RBG-47553

SUBJECT: Response to Request for Additional Information on License
Amendment Request 2013-13
River Bend Station – Unit 1
Docket No. 50-458
License No. NPF-47

Response to Request for Additional Information

Estimate of Potential Liner Leakage in a Gate Load Drop Scenario

Ref. EV-003A, EV-003AY, EV-003BH

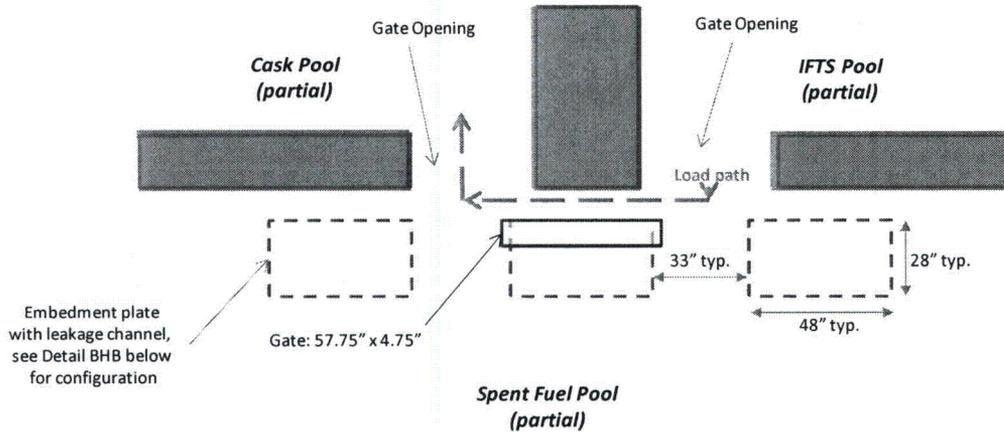
The embedment plates located on the pool floor in the gate load path area between the IFTS pool opening and the Cask pool opening are 28" x 48". The spacing between the edges of the plates is (6' 9" - 48") = 2' 9". A sketch showing the general plate location in the load paths and the detail of the leakage channel is provided below.

As shown on the sketch above, the largest damage to the leakage channel area would result from a gate strike along one 48" side of the embedded plate. Damage to the short sides of the embedded plate channel would equal the thickness of the gate or 4 3/4" on each side.

$$\text{Damaged channel length} = 48" + (2 * 4.75") = 57.5"$$
